INSPECTION REPORT
Sedimentation Structure
WW-5
Black Mesa Mine
Navajo County, Arizona
for
PEABODY COAL COMPANY

Dames & Moore
10139-011-22

**SITE PLAN
WW-5**

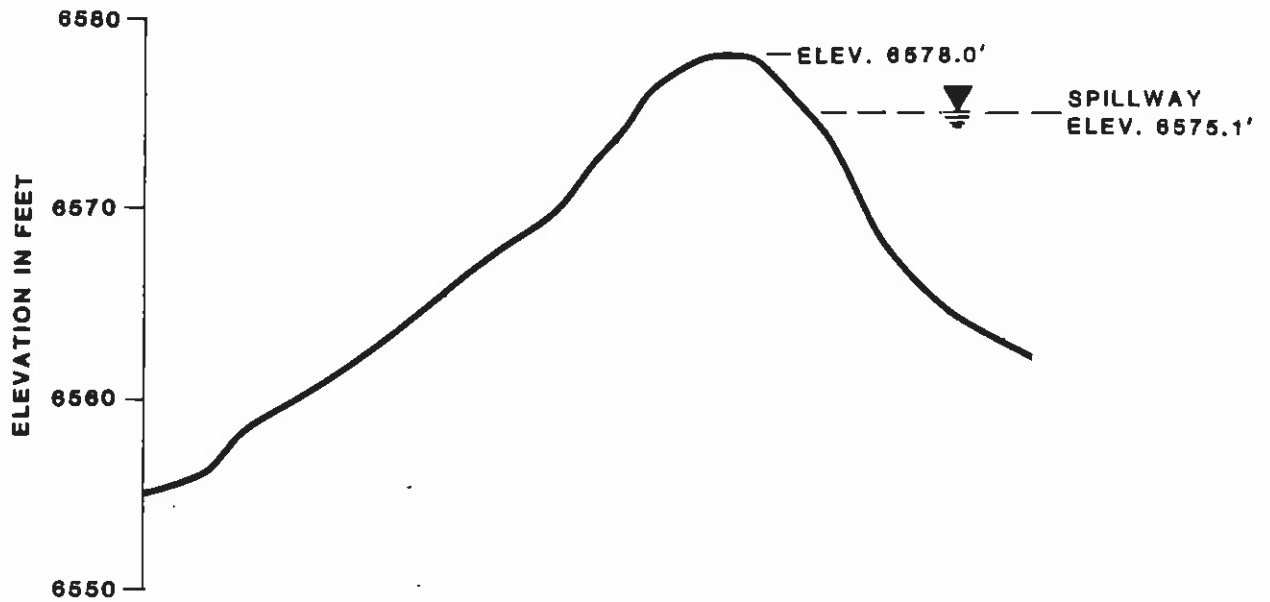
The storage capacity and spillway capacity of Structure WW-5 are adequate; however, the spillway does not have an adequate outflow channel or adequate erosion protection. A trapezoidal outflow channel should be constructed along the alignment B-B' shown in Plate 1. The channel profile is shown in Plate 4 and the required dimensions are shown in Plate 5. Both the spillway and outflow channel should be protected against erosion using geotextile and gravel as shown in Plate 5.
